LSV 67 A BK

LSV67A

2160110 Exploded views

Notices

0210007: SOFT CLOSURE ON BUILT-IN DISHWASHER BROKEN

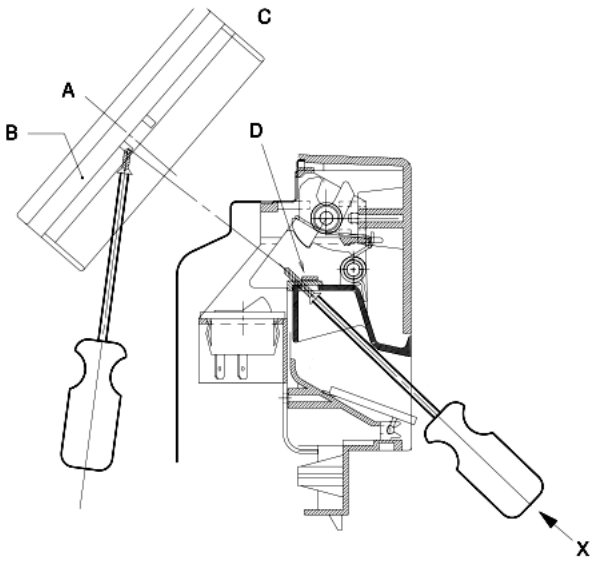
Breakage of "soft" handle on the facia of built-in dishwashers
If the tabs of the internal block should break, making it impossible to reach inside the machine, follow these steps:
1) Fit a cross screw-driver with a 3.5 x 16 self-locking screw on the tip, into the handle housing.
Fit the screw into one of the two slots shown in the drawing (view from x), screwing half of the screw in.
If the above prcoedure has been carried out correctly, when you pull the handle the door will open.
2) The handle unit must then be replaced.
fig.2110019A
A View from X
B Handle
C Door locking assy soft
D Internal block shouldbreak

n1045020: New door gaskets

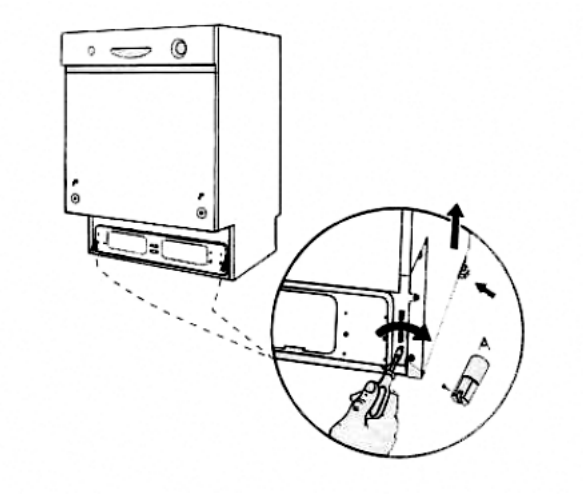
In order to eliminate any emission of steam from the door, new "TECAR" door gaskets are being used. The new parts keep the same spare part no. 059637 for 60 cm appliances and 063853 for 45 cm ones.

Before replacing the door gaskets, the following operations should be carried out:
Check whether there is any creasing on the corners, and if so then remove the seal and reassemble it correctly.
Use silicone to fill up any cracks in the frame (top left- and right-hand part).
Every time any intervention is carried out on the gasket, make sure the appliance is perfectly level in order to improve the assembly and replacement procedures.

n1045033: Kit of adjustable feet for dishwashers LVS2000, 140 mm high.

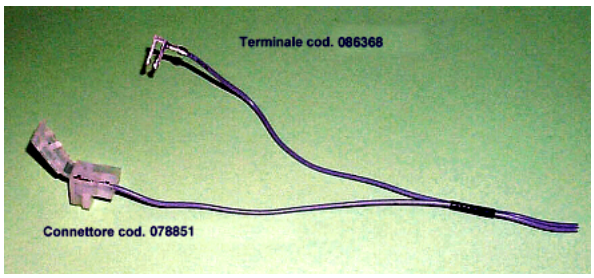
In order to cope with the increasingly frequent demand from furniture manufacturers, new 14 cm height-adjustable feet are being used on dishwashers LVS2000.
Moreover, a kit of adjustable feet has been made available which allows the worktop to be adjusted to a height of up to nine centimetres.
Spare part number of the Kit:
066655 KIT OF ADJUSTABLE FEET H.140
Spare part numbers for each individual foot:
066653 ADJUSTABLE FOOT WITH NUT H.140 MM
074435 ADJUSTABLE FOOT H=140 MM.

N1045063

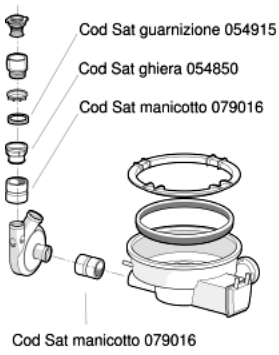
From serial number 30224.0001, all dishwashers affected by this modification have been equipped with the new coupling+ring nut assembly Sat code 093752, in place of coupling Sat code 079016, ring nut Sat code 054850 and gasket Sat code 054915.
Ring nut Sat code 054850 will continue to be available from the spare parts warehouse while stocks last, and coupling Sat code 079016 will continue to be stocked because it is still used for the tank-volute connection.
Picture N1045063 illustrates the premodification structure in FIG1 and the new structure in FIG2.

FIG. 1
STRUTTURA
PREMODIFICA

FIG. 2
NUOVA
STRUTTURA
